Addendum 5

May 8, 2026

**KINGS BRANCH AT ARROWOOD ROAD STREAM RESTORATION  
PHASE 2A  
MECKLENBURG COUNTY, NORTH CAROLINA**

**MODIFICATIONS TO THE CONSTRUCTION DRAWINGS**

SHEET	OF
C-4.1	33

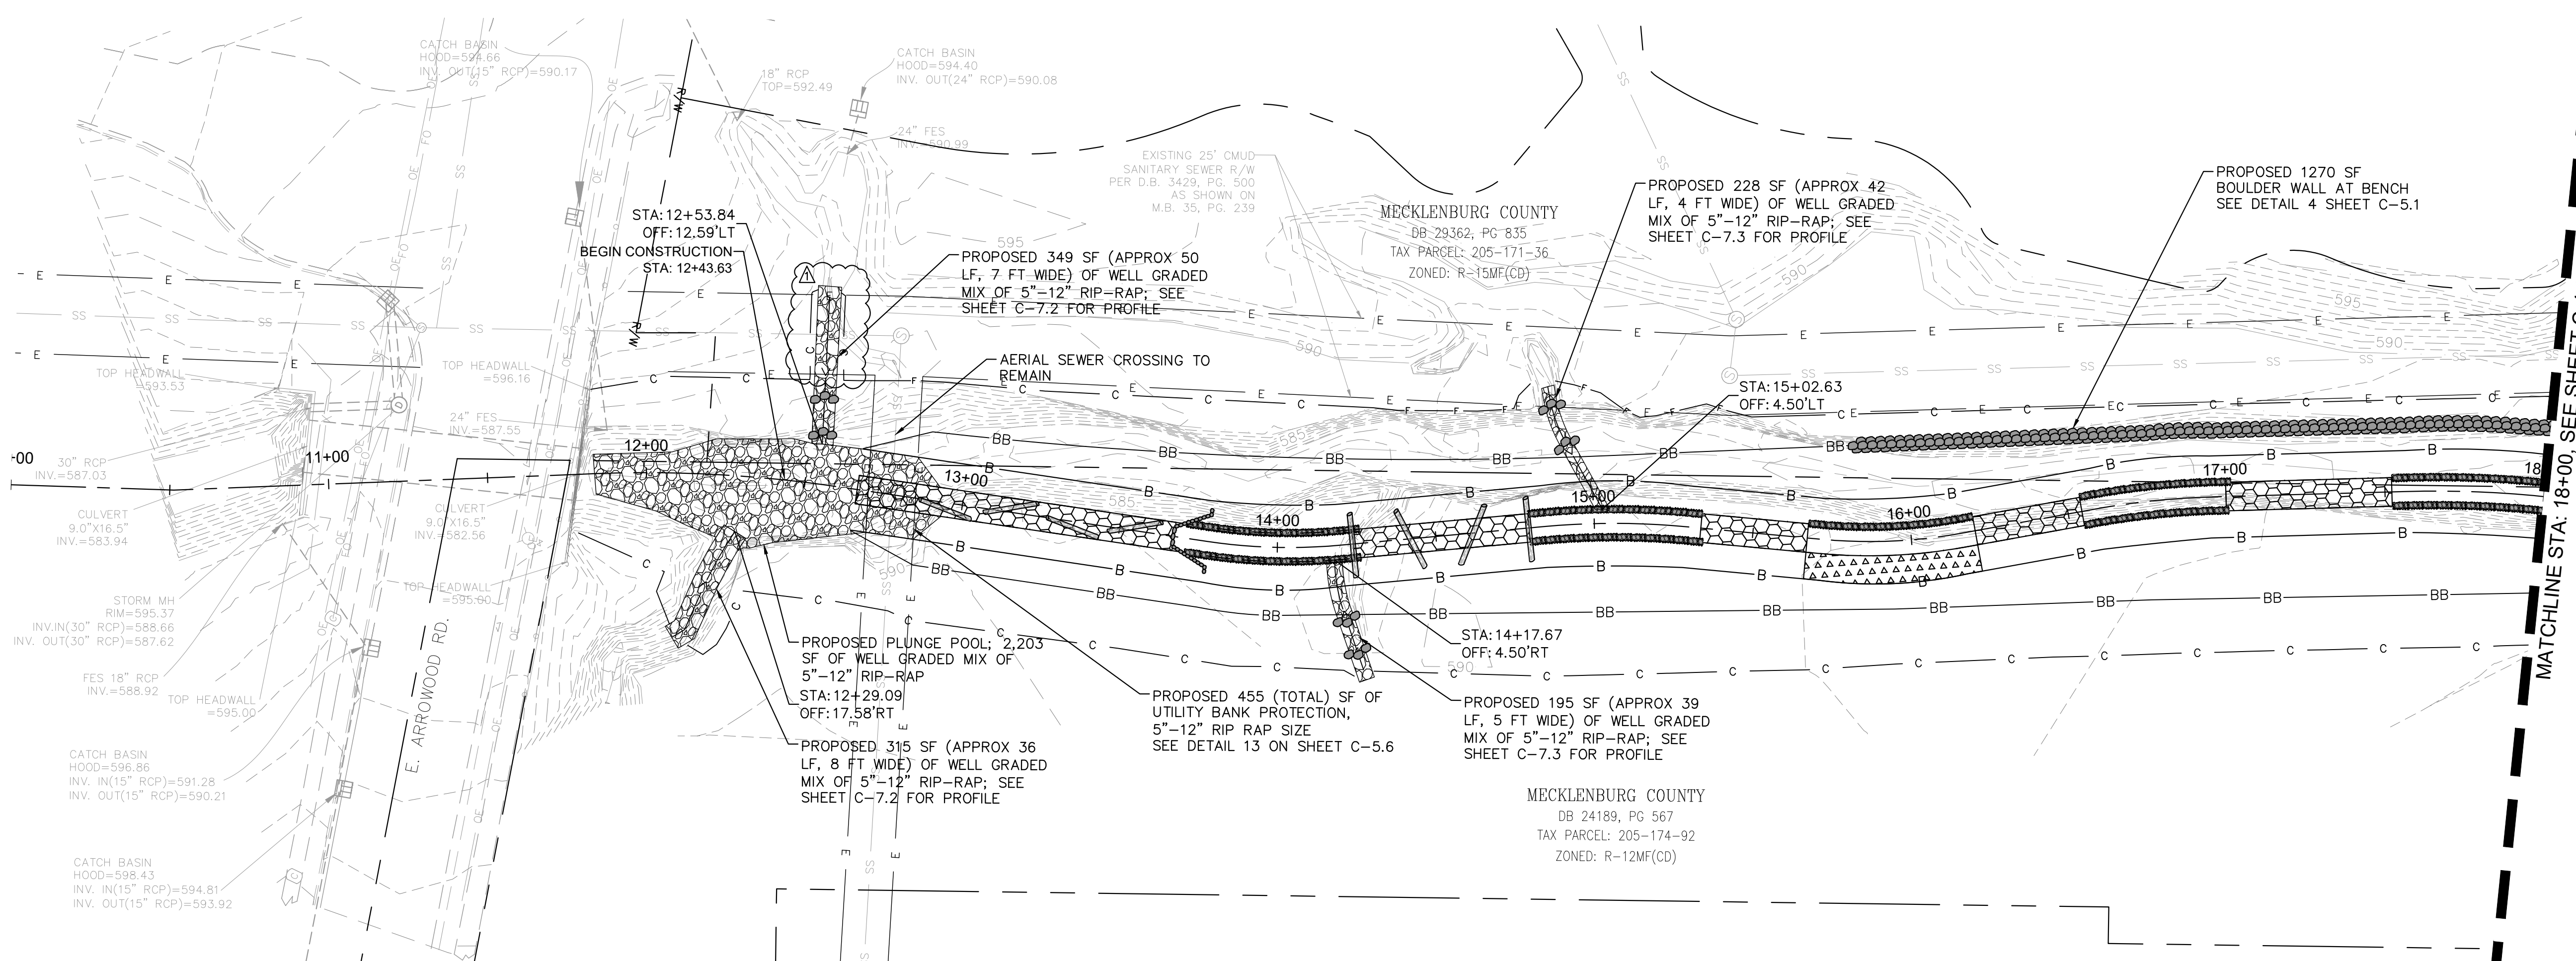
Sheet C-4.1:

- Updated cut line for Tributary 2

SHEET **C-7.0** OF **33**

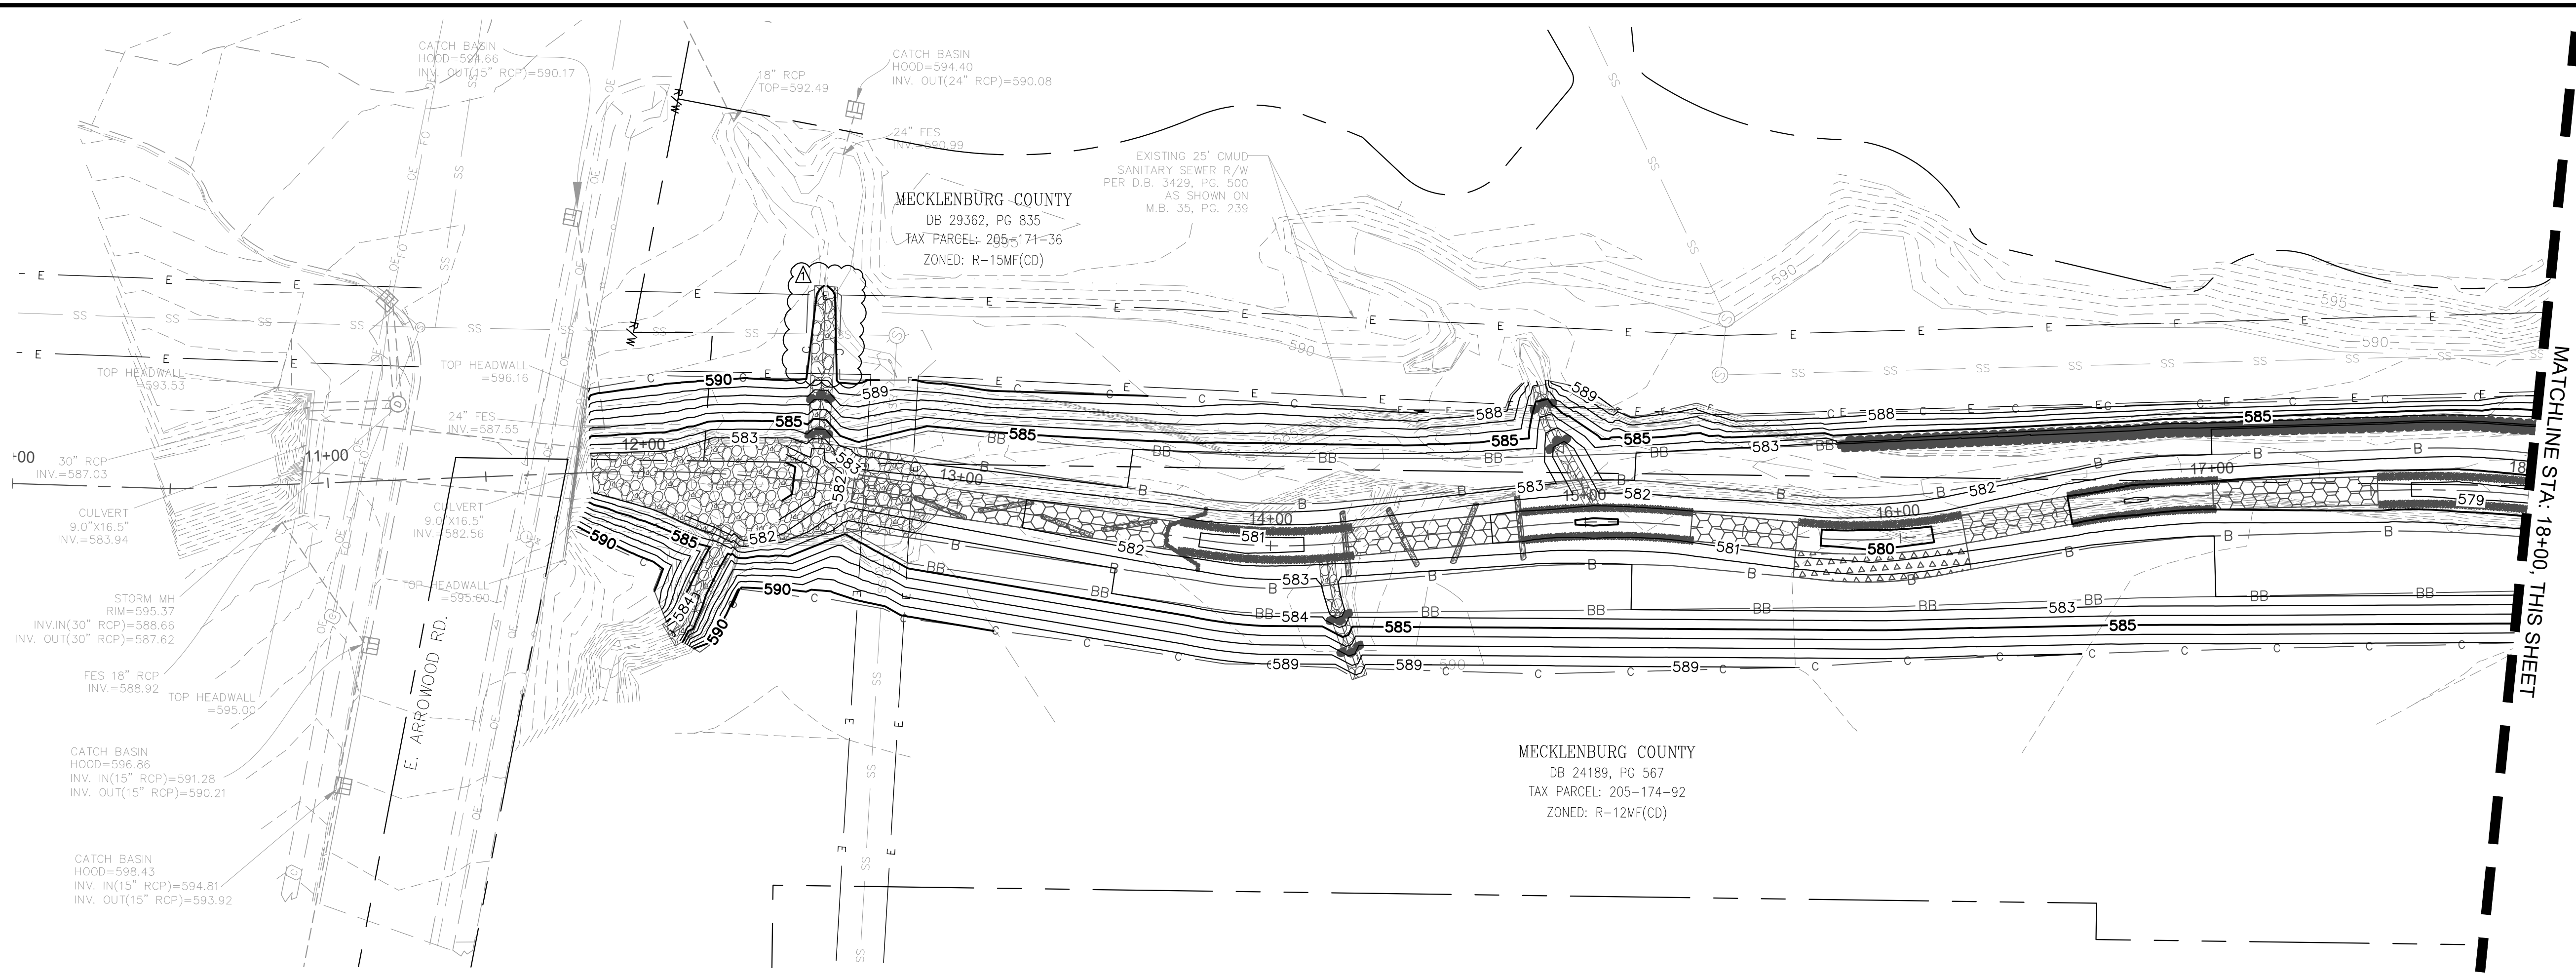
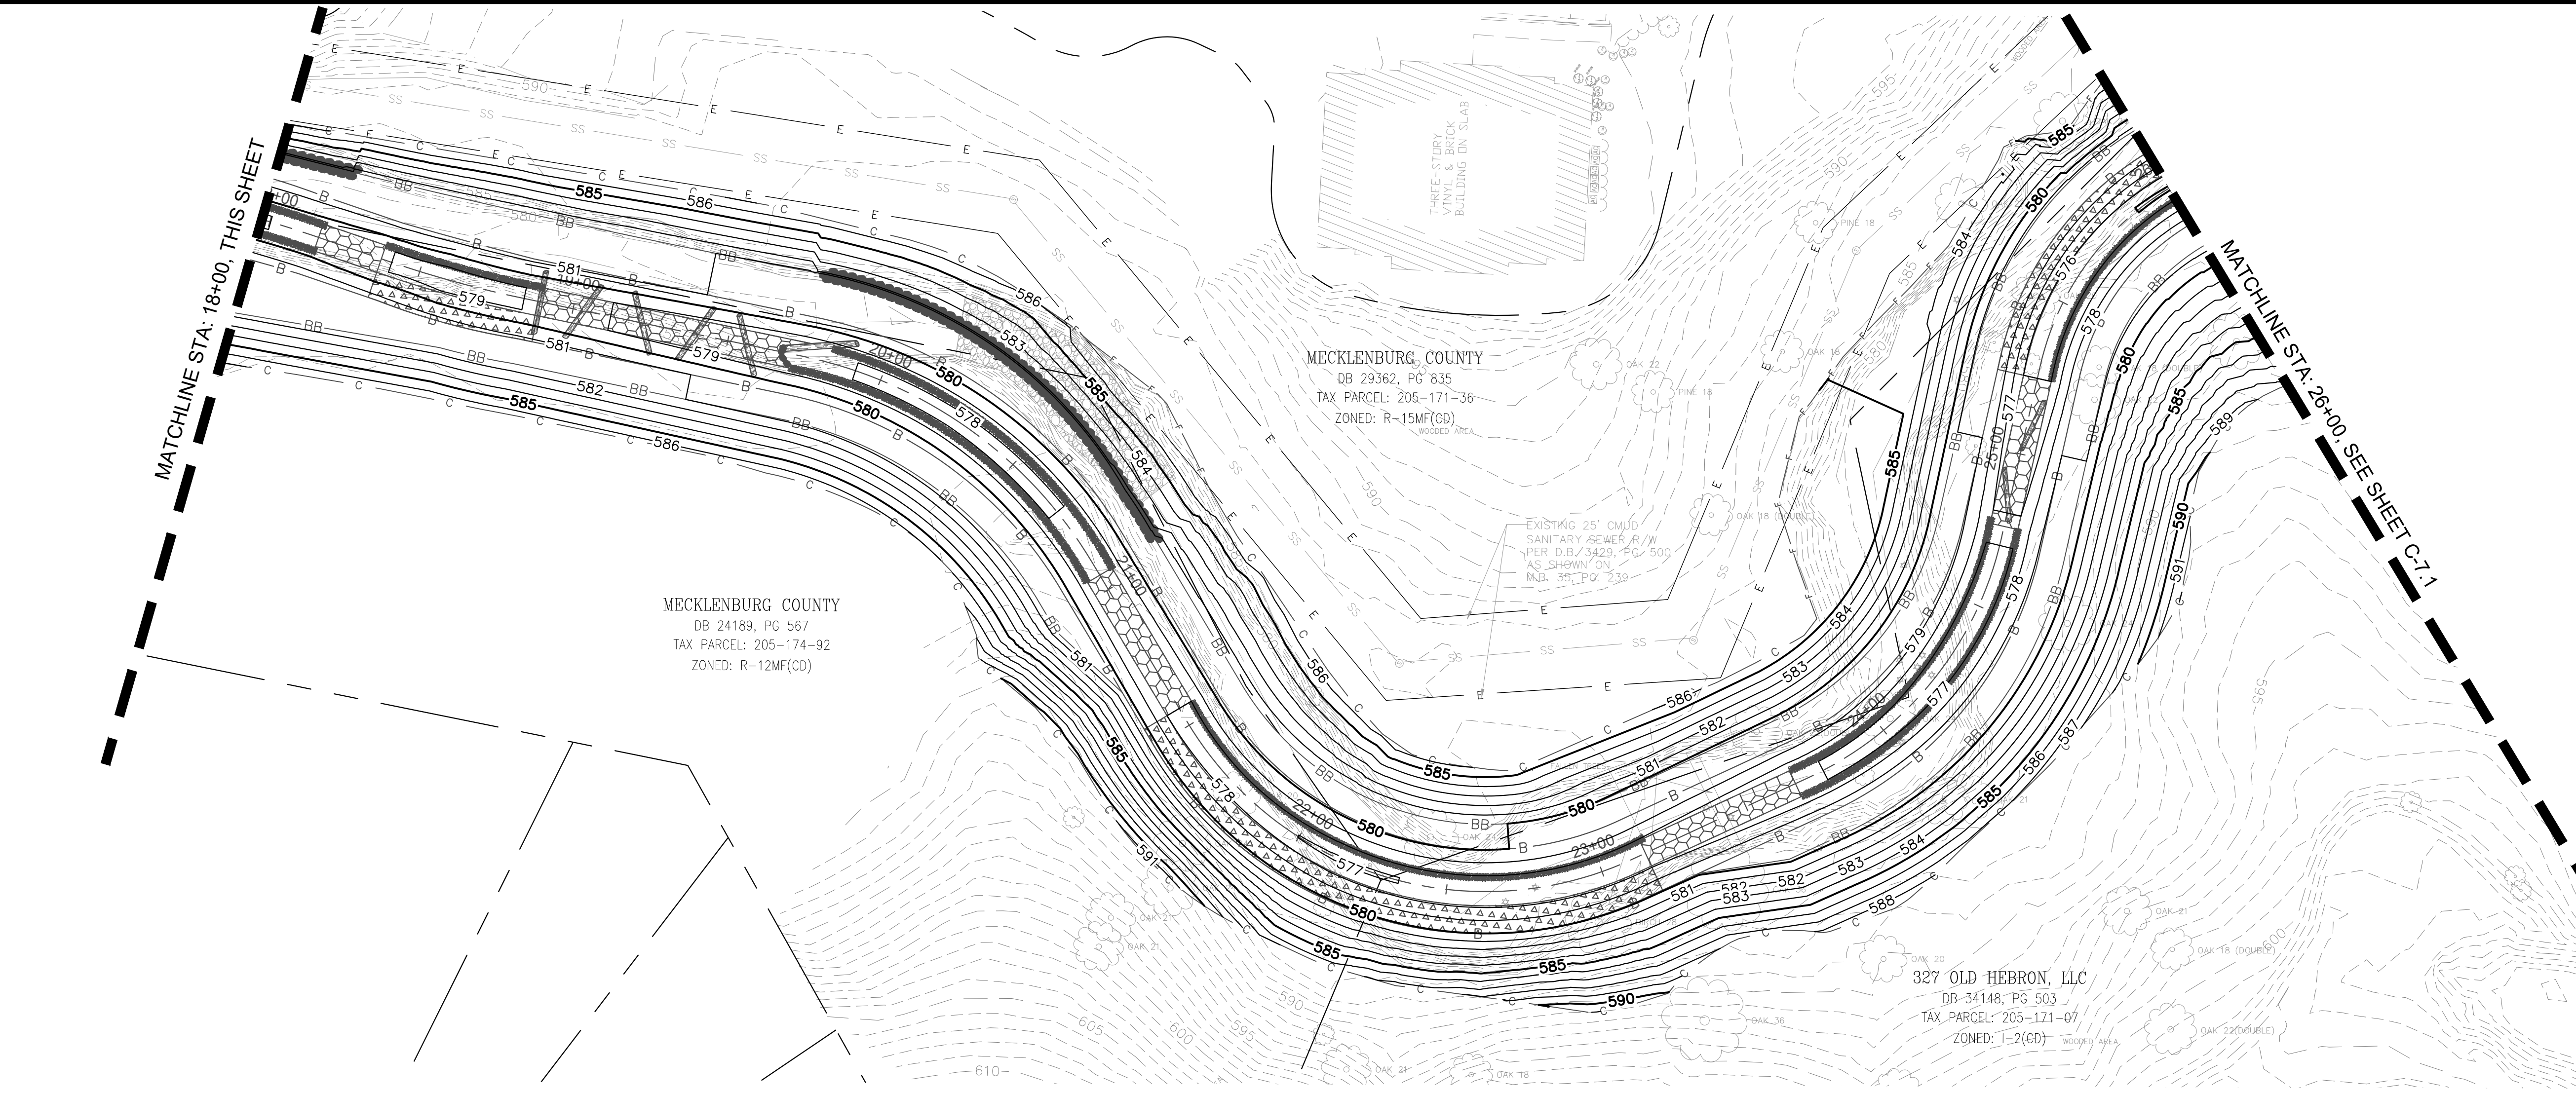
Sheet C-7.0:

- Updated cut line for Tributary 2

TRIBUTARY 2 - APPROXIMATELY STA. 12+54  
Hor. Scale: 1"=30' | Vert. Scale: 1"=3'

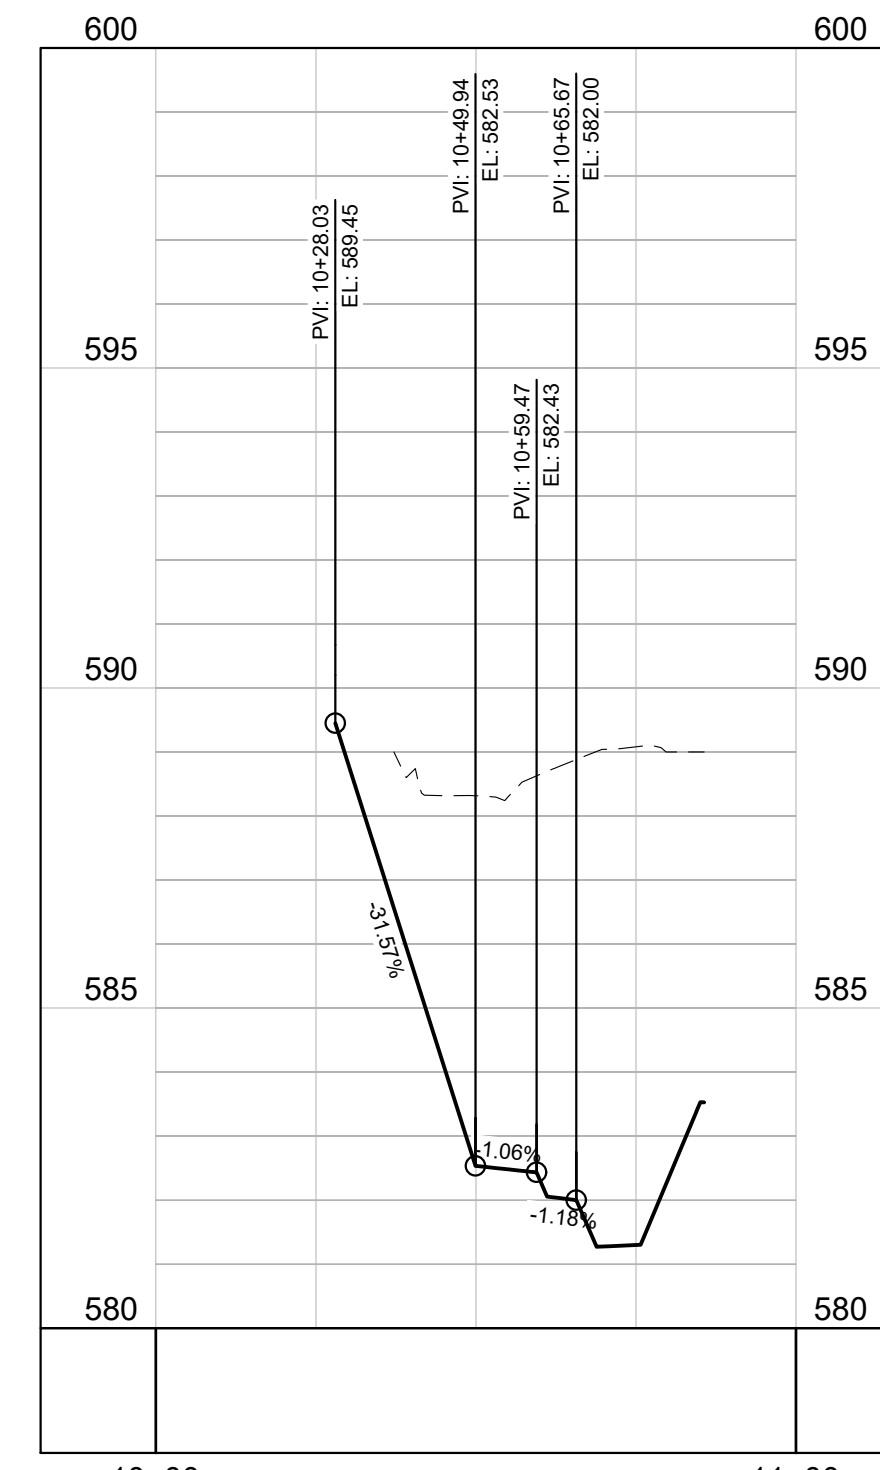
Sheet C-7.2:

- Updated cut line for Tributary 2

VEGETATION NOTES  
AND DETAILS

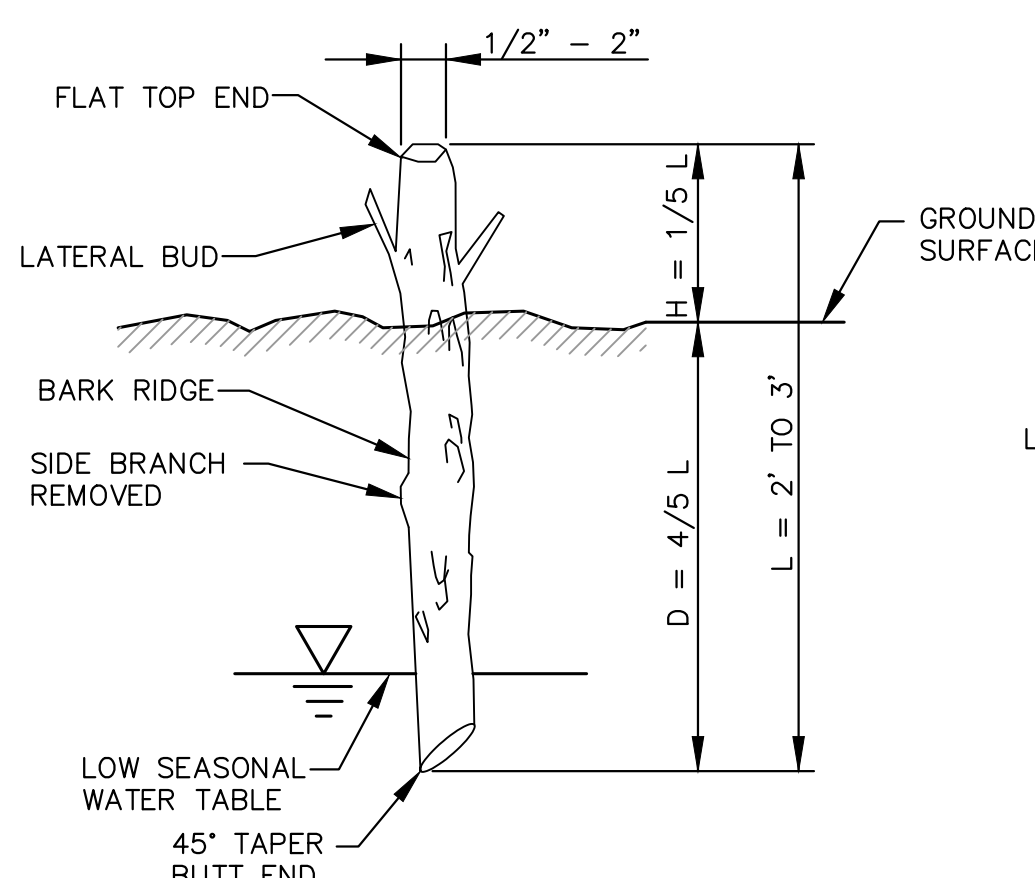
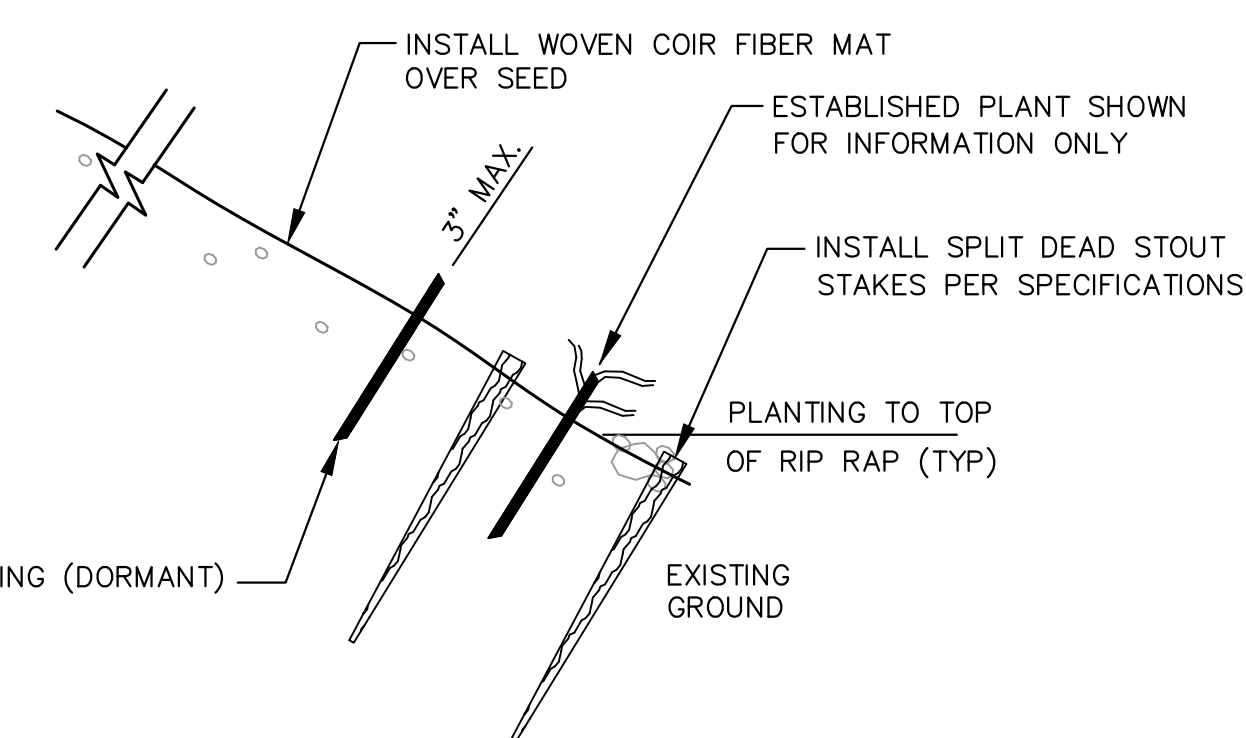
Sheet C-8.0:

- Percent mix values updated for River Oats and Switchgrass

23. Note #4 on Sheet #C-8.0 says to apply 1.5" of topsoil/compost mix over Zones A & B. Is the intent to simply mix in the compost with on-site topsoil, and is this meant to be applied at or above finished grade?

**Compost has been removed from the Organic Soil Amendments. The 1.5" of topsoil mix is intended to be applied above finished grade.**
